REMARKS

This paper is in response to the official action dated July 9, 2003 (hereafter, the "official action").

Fig. 3

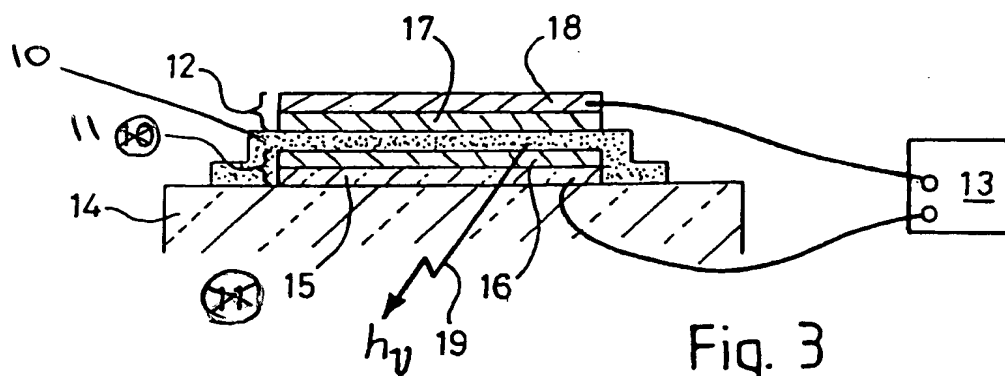
Figure 3 of the drawings has been amended to include correct reference numbers corresponding to those provided in the specification. Additionally, the previous abstract has been canceled and a new abstract is submitted herewith.
